# City of Richmond

## Report to Committee

**Re:** Application by Kanaris Demetre Lazos for a Heritage Alteration Permit at  
12111 3rd Avenue (Steveston Hotel)

**WINDOW REPLACEMENTS  
OF SECOND FLOOR ONLY**

**EXISTING ELEVATIONS**  
SCALE: 1/8"=1'-0"

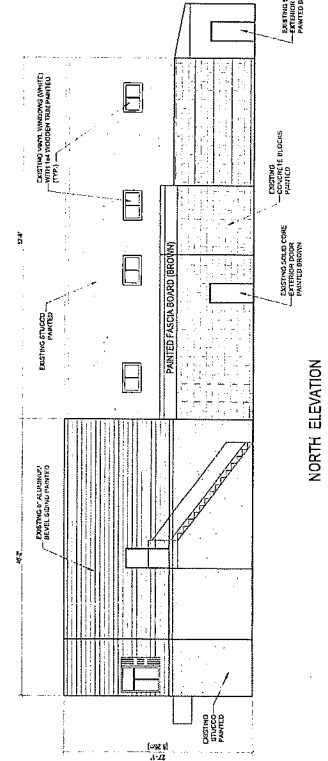
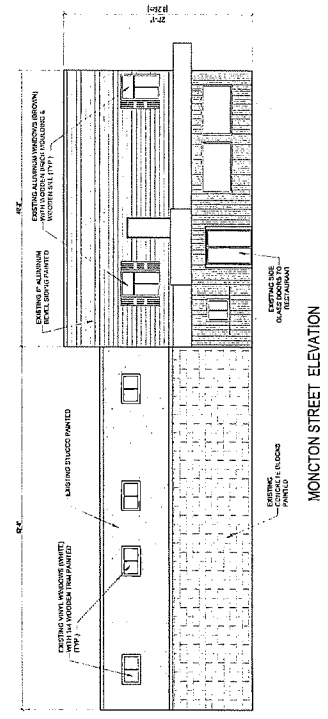
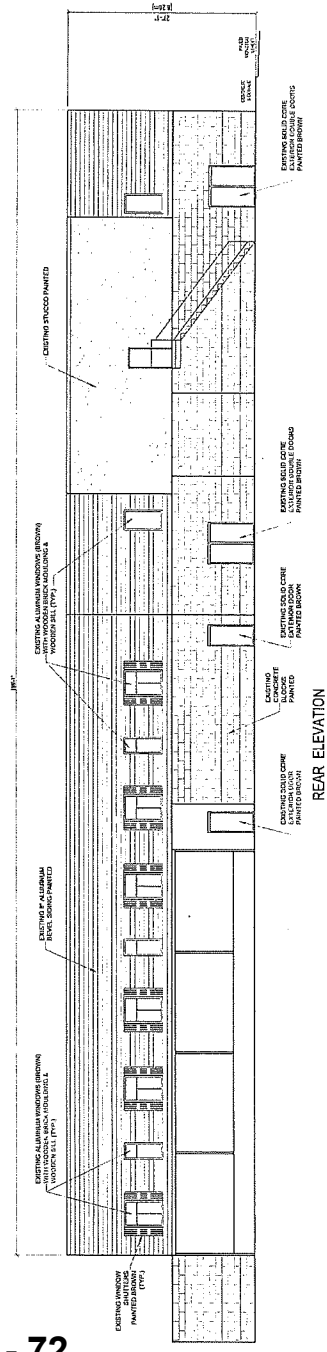
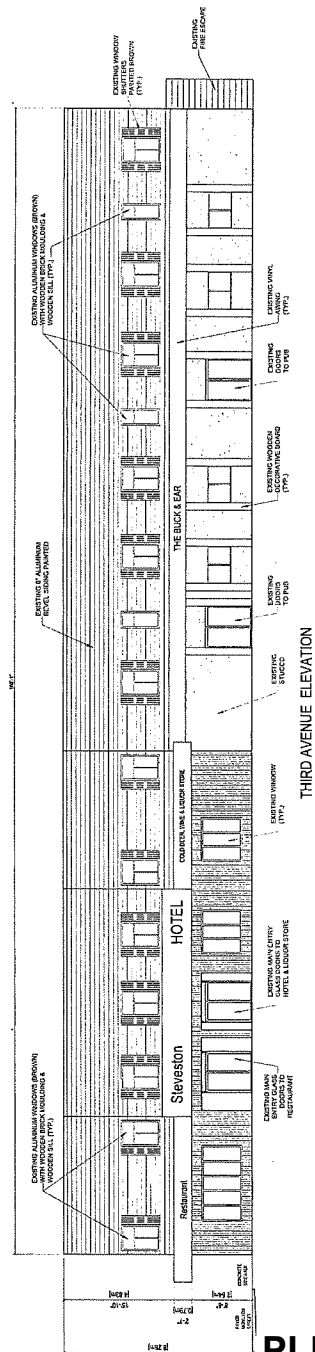
THIS DRAWING HAS BEEN PREPARED FOR AN APPLICATION DESIGNED TO REMOVE ALL EXISTING WINDOWS OF THE SECOND FLOOR AND REPLACE THEM WITH NEW DOUBLE GLAZED VINYL WINDOWS. EXISTING WOODEN TRIM AROUND EXISTING A WOODEN WINDOW (S) TO REMAIN AS IS SET. REPAIRED, PAINTED THE SAME COLOR AS NEW WINDOW.

ALL NEW WINDOWS TO BE BLACK. ALL WINDOWS TO BE CLEAR GLASS EXCEPT BALCONY WINDOWS WHICH WILL BE TINTED GLASS.

ALL WINDOWS TO BE WITH CHANGES EXCEPT BALCONY WINDOWS WHICH ARE TOP PUSH-OUT.

**Excerpt of Minutes**  
**Richmond Heritage Commission**  
Held Wednesday, March 21, 2018 (7:00 pm)  
M.2.004  
Richmond City Hall

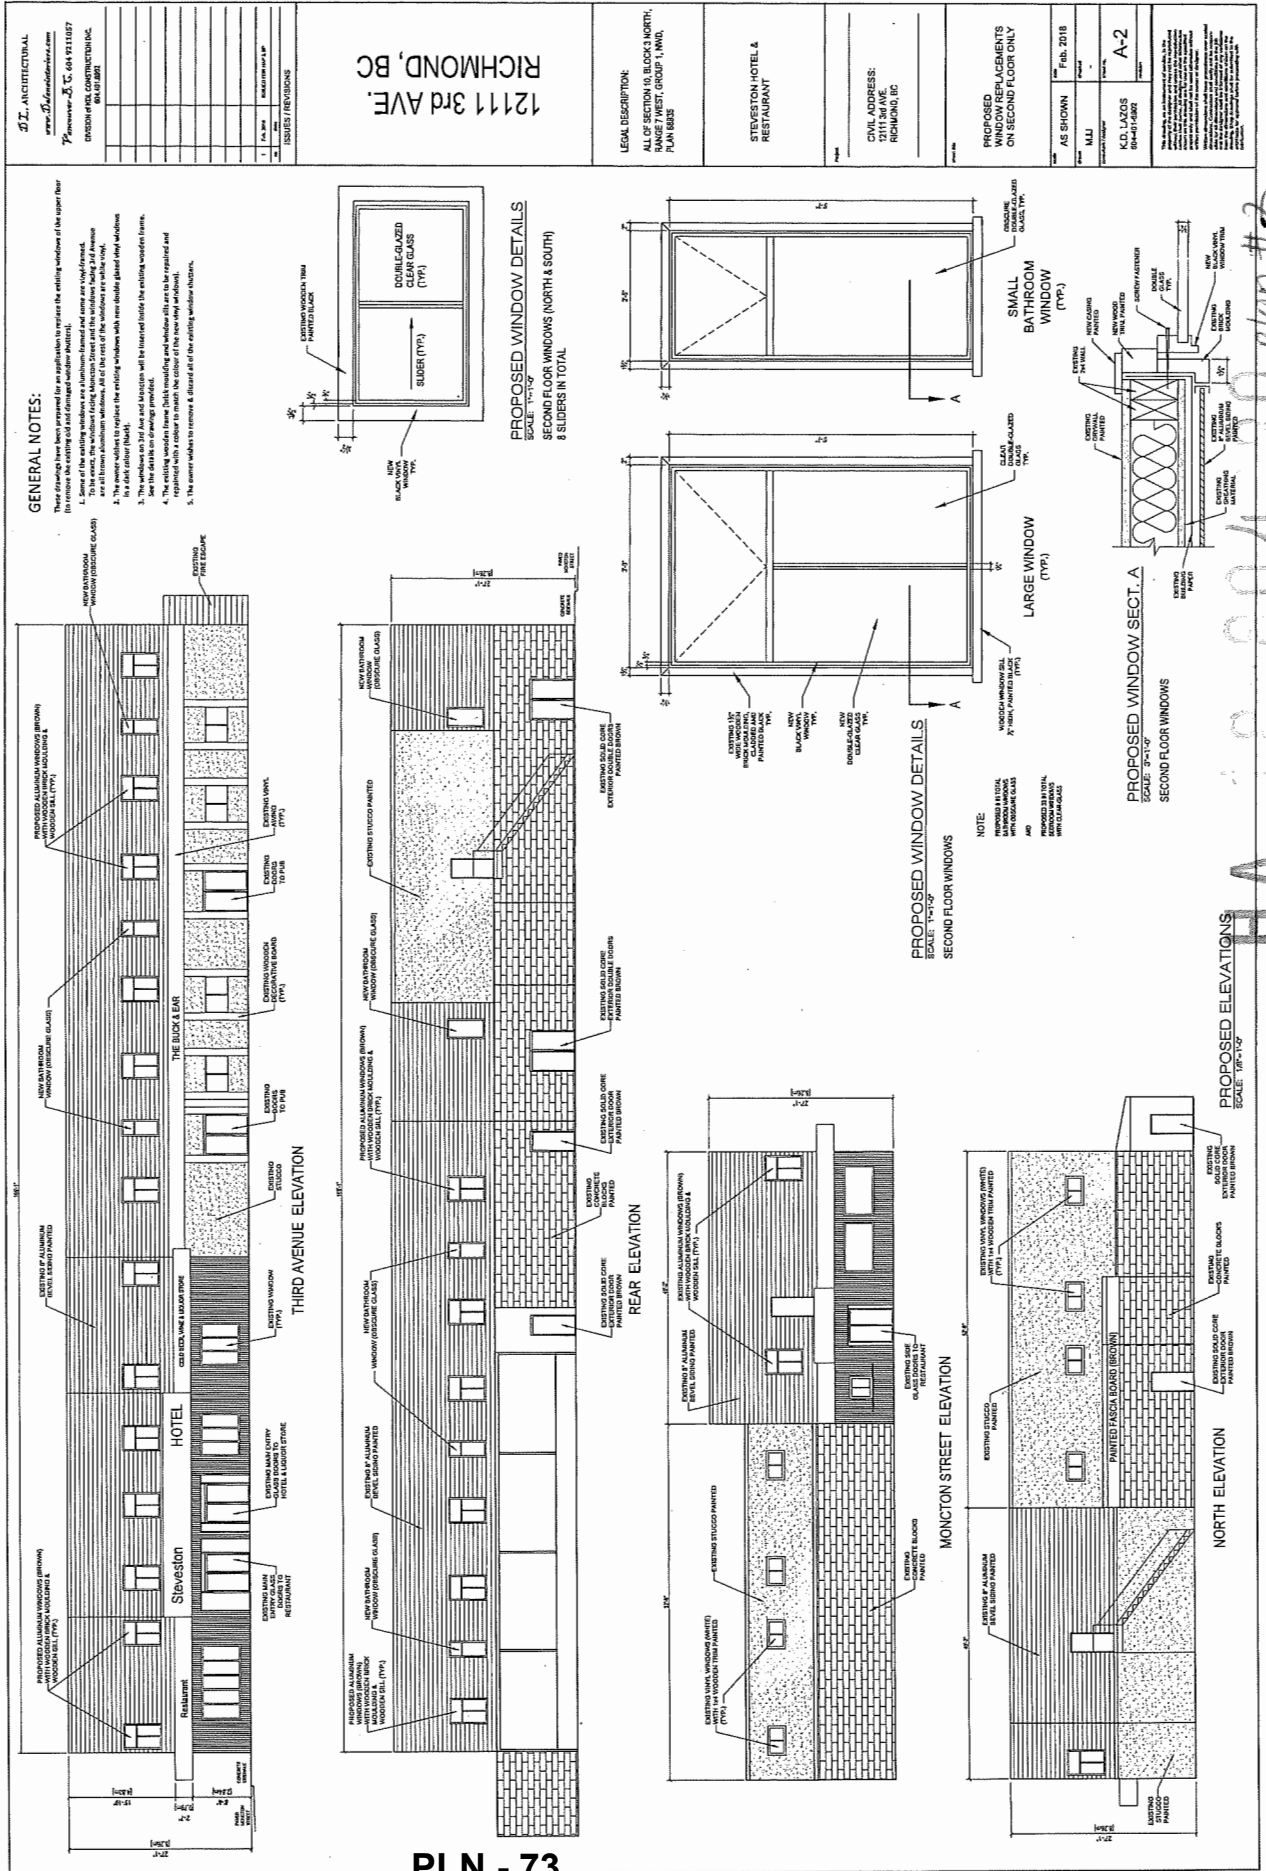
Staff summarized the Heritage Alteration Permit application to highlight the key points. It was noted that the applicant is applying to remove the decorative shutters and replace the windows on the upper level. The applicant is proposing black vinyl-framed windows. It was noted that the existing frame is ¾ inches and the proposed frame is narrower than the existing one.

The applicant answered questions on the installation process. It was noted that the window sills and brick moulding will be kept. It was further noted that these are upper-storey windows only and are not easy to see from the street level. The applicant noted that he would prefer a wider frame, but decided to go for a narrower frame to achieve the similar look as the existing aluminum frames.

Staff noted that two different types of glazing are proposed. Most of the windows will have clear glazing but the eight bathroom windows will have fogged glass.

Members discussed the proposed window patterns and noted that the proposed pattern with the T-shaped divider is supportable as it would help achieve the historic look.

***That the Richmond Heritage Commission support the proposed windows and removal of existing shutters as presented.***
